## DEVELOPMENT APPLICATION ASSESSMENT REPORT

<b>Application Number:</b>	DA2019/0239
----------------------------	-------------

<b>Responsible Officer:</b>	Daniel Milliken
<b>Land to be developed (Address):</b>	Lot 1 DP 1001963, 638 Pittwater Road BROOKVALE NSW 2100
<b>Proposed Development:</b>	Demolition Works and construction of a mixed use development
<b>Zoning:</b>	Warringah LEP2011 - Land zoned B5 Business Development WLEP Land identified in Schedule 1 Additional Permitted Uses. Refer to attached extract of WLEP2011
<b>Development Permissible:</b>	Yes
<b>Existing Use Rights:</b>	No
<b>Consent Authority:</b>	Northern Beaches Council
<b>Delegation Level:</b>	NBLPP
<b>Land and Environment Court Action:</b>	No
<b>Owner:</b>	Marval Property Pty Ltd S & A Apartments Pty Ltd RNSAL Property Enterprises Pty Ltd
<b>Applicant:</b>	BBF Town Planners

Northern Beaches Council is in receipt of Development Application No. DA2019/0239 for a three storey shop top housing development with basement car parking located at No. 638 Pittwater Road, Brookvale.

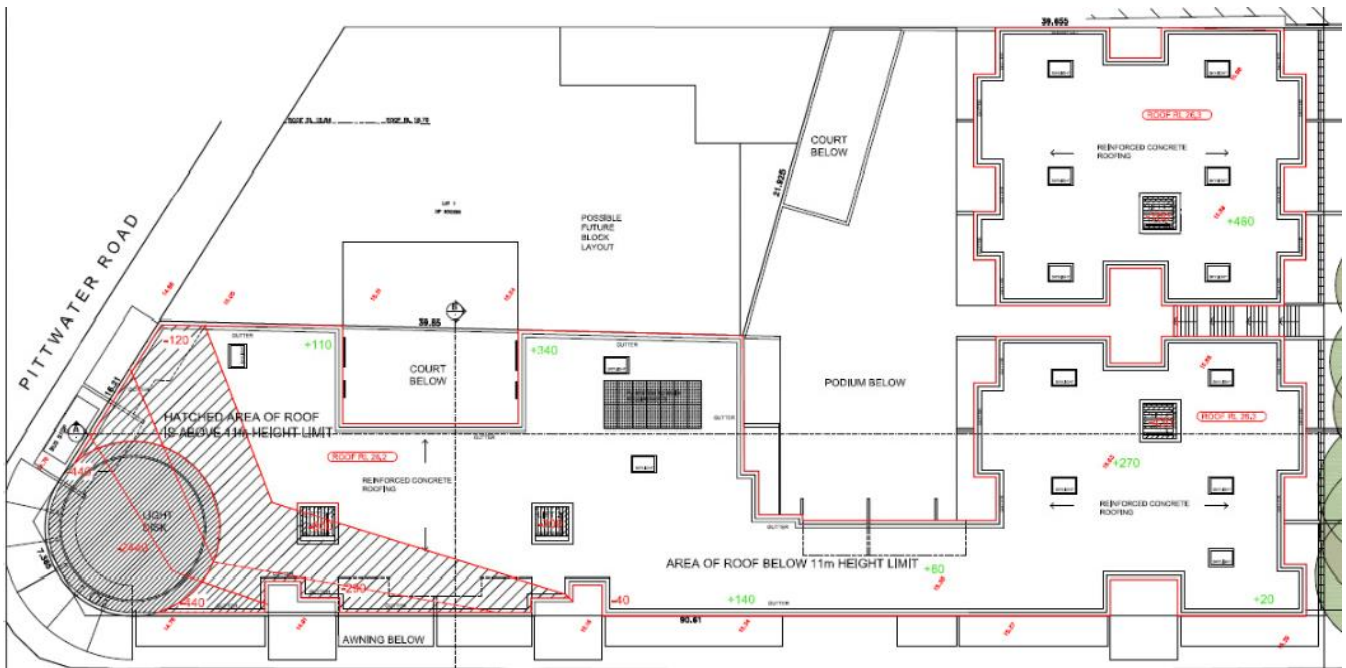
*Consent must not be granted under this clause to development for the purposes of shop top housing unless the consent authority is satisfied that the development will not have a significant adverse impact on any adjoining land in Zone IN1 General Industrial.*

Comment: The impacts on adjoining land is discussed below in this report. In summary, the proposal will not have a significant adverse impact on the adjoining IN1 General Industrial zoned properties. This is achieved by the 6m building setback, retention of mature trees and landscaping to Charlton Lane to assist with reducing noise and visual impacts. Suitable conditions requiring compliance with the acoustic report, to reduce the impacts to the apartments adjoining the IN1 zone, have been included in the recommendation.
